ADDENDUM NO. 1 ELEMENTARY ADDITION TO SUMTER CENTRAL HIGH SCHOOL

Architect Job No. 24-38 July 24, 2024 DCM # 20240619

PROJECT:	PROJECT NO.	REFERENCE:
ELEMENTARY ADDITION TO SUMTER CENTRAL HIGH SCHOOL	24-38	ADDENDUM NO. 1
ARCHITECTURAL ADDENDUM DRAWING	DATE:	SHEET NO.
ANCHITECTORAL ADDENDOW DRAWING	7/10/2024	ADD 1

<u>LIGHTING - FLOOR PLAN - PART C</u>

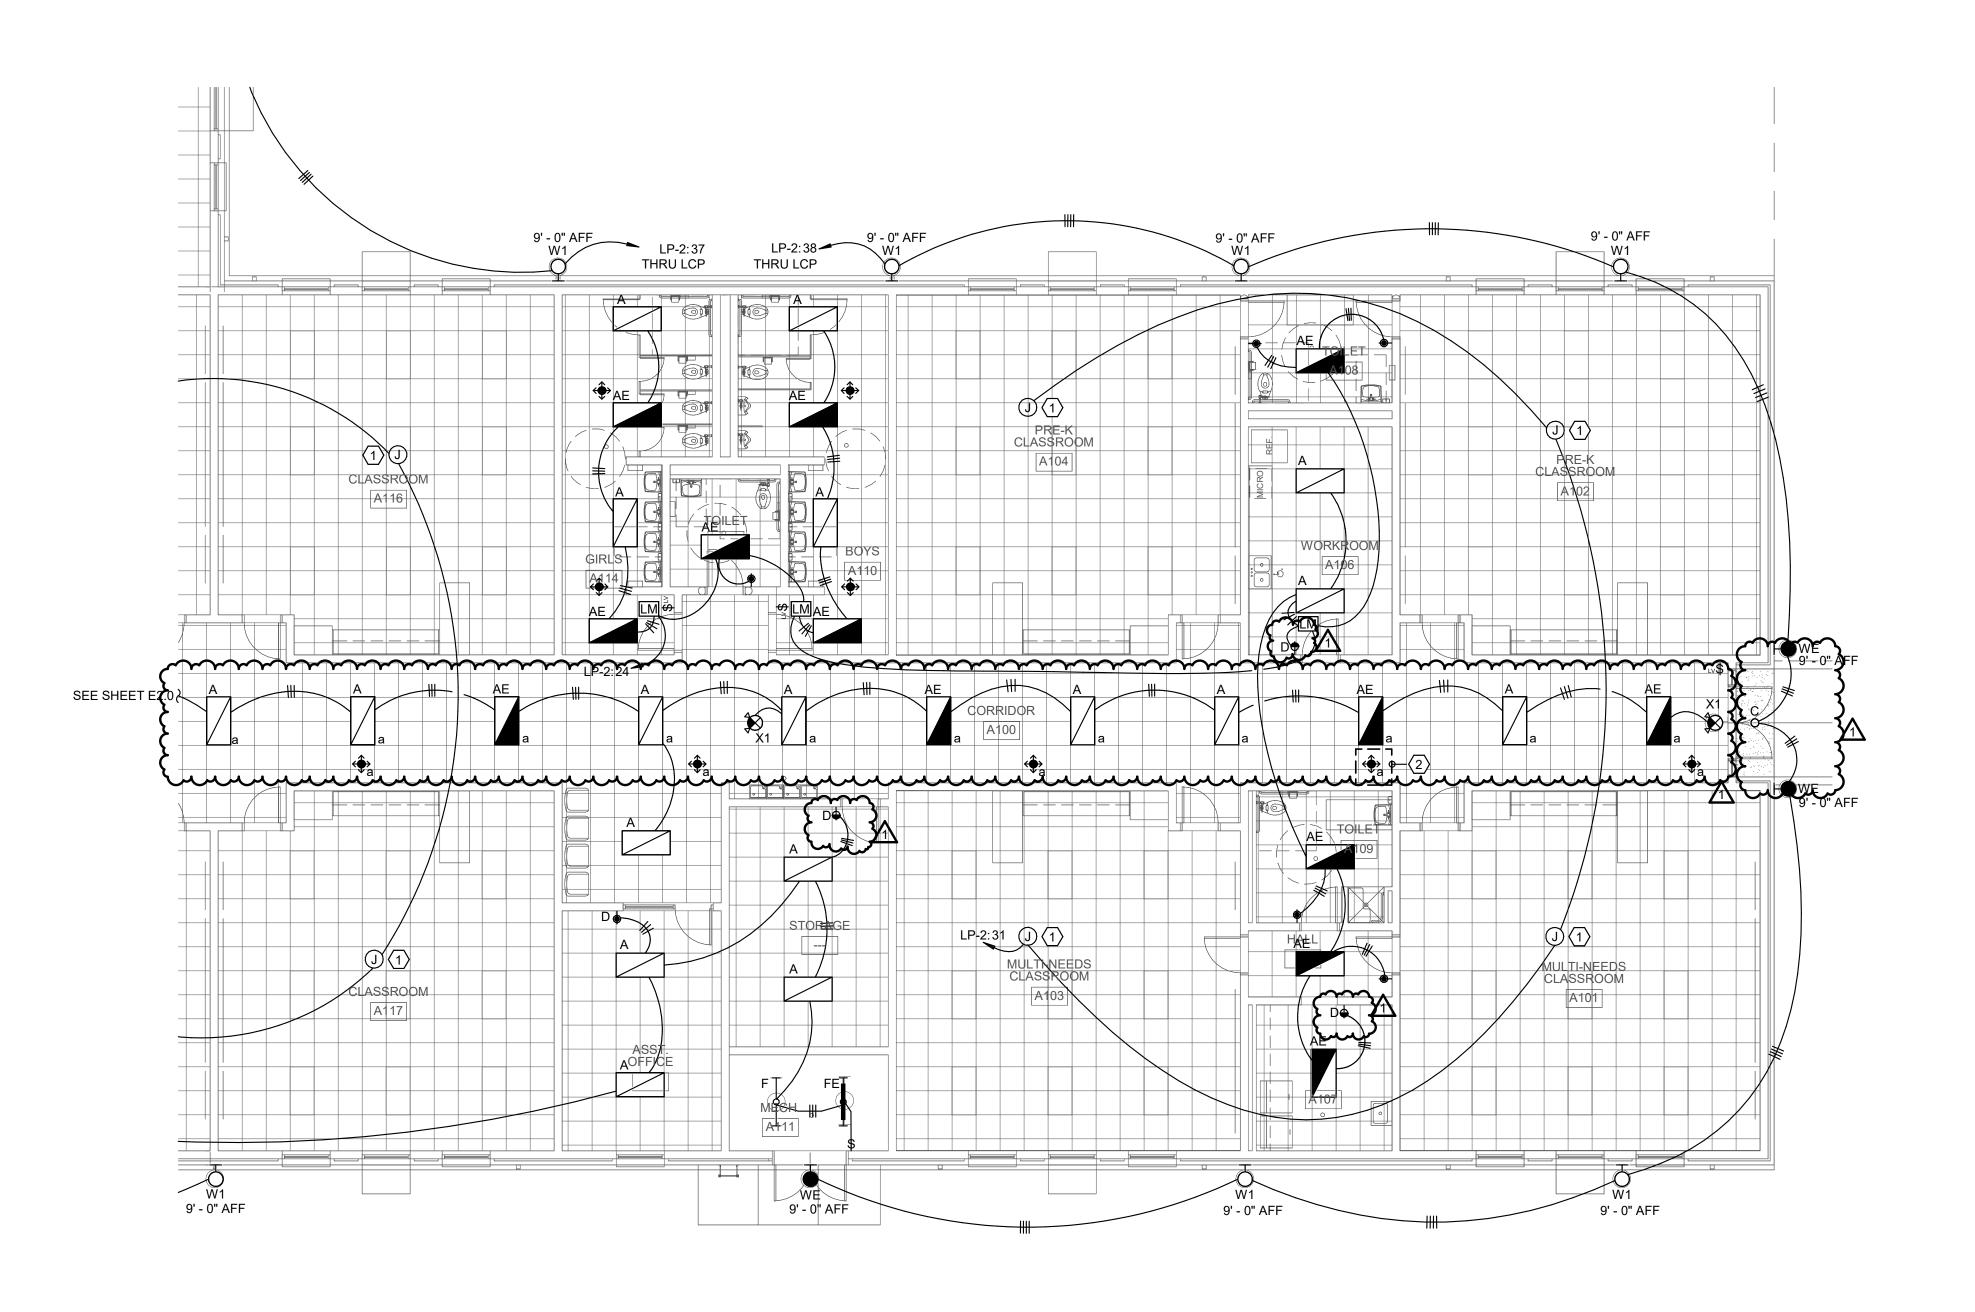
- 32. See attached **E2.0** revised to provide continuous dimming in addition to full ON and Full OFF.
- 33. See attached **E2.1** for Storage D103 to have vacancy wall switch "Manual on".

E2.2

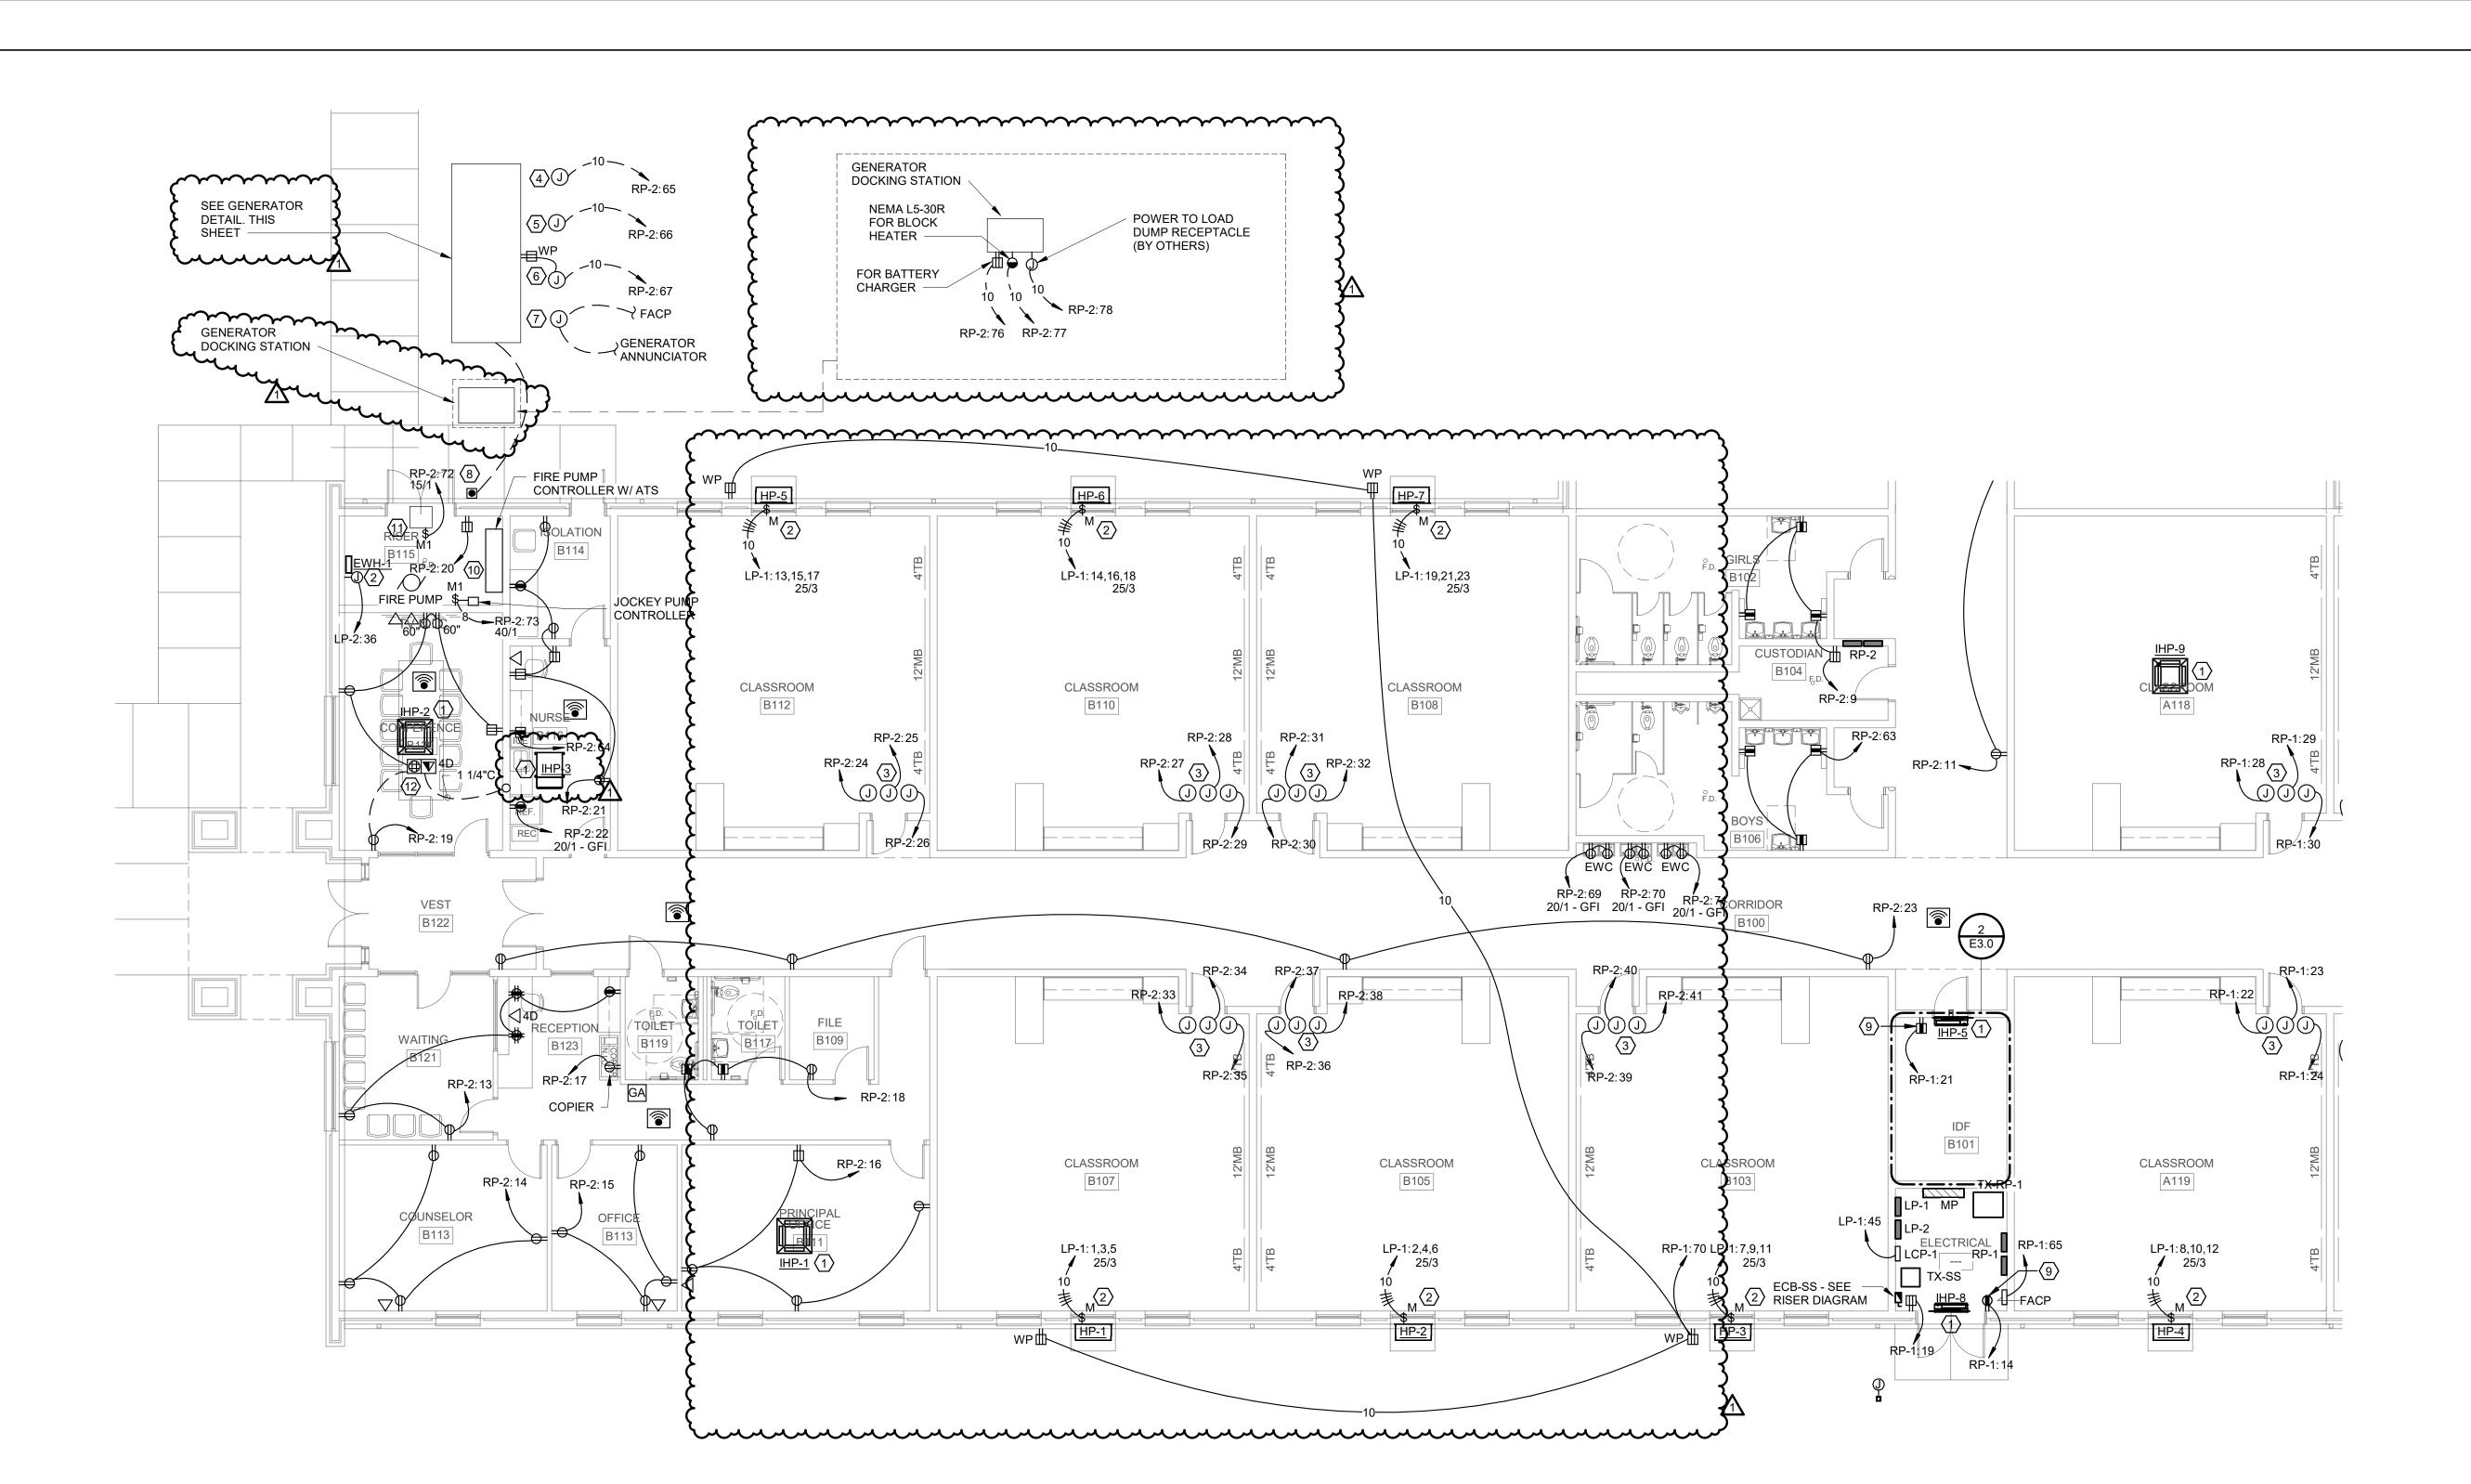
- 34. See attached **E2.2** for Storage A120 to have vacancy wall switch "Manual on". Revised for Workroom A106 to provide continuous dimming inn addition to full ON and Full OFF.
